Project Name: South Rim Filing #4

File No. FPP-95-181

RE: GENERAL PROJECT REPORT for: SOUTH RIM, FILING FOUR, FINAL PLAT & PLAN.

FILE: #FPP- 95-181  
DATE: October 12, 1995  
STAFF: Michael Drollinger  
REQUEST: Final Plan & Plat - South Rim Filing #4  
LOCATION: E end of South Rim Drive  
ZONING: PR-3.5

**BICYCLE PATH PLAN**  
**SOUTH RIM**  
**FILING NO. FOUR**

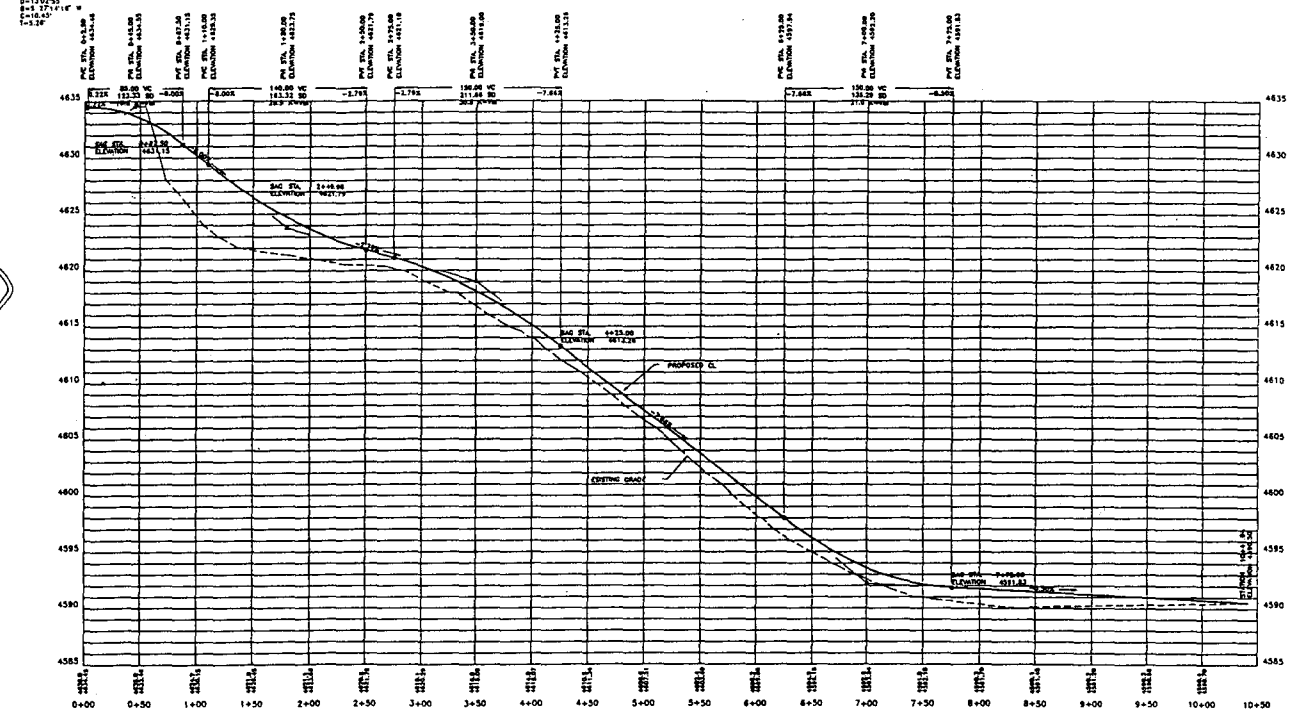
1. The plan is deficient and needs to address the following: show a profile, grades, and a cross section which shows maximum cut and fill slopes. Provide a scale for the drawing. Signing will be required as part of the construction. A bollard or other deterrent to motorized vehicles may be required by Parks at the trail entry on Promontory Court. Some useful information on bike path design and signing is attached.
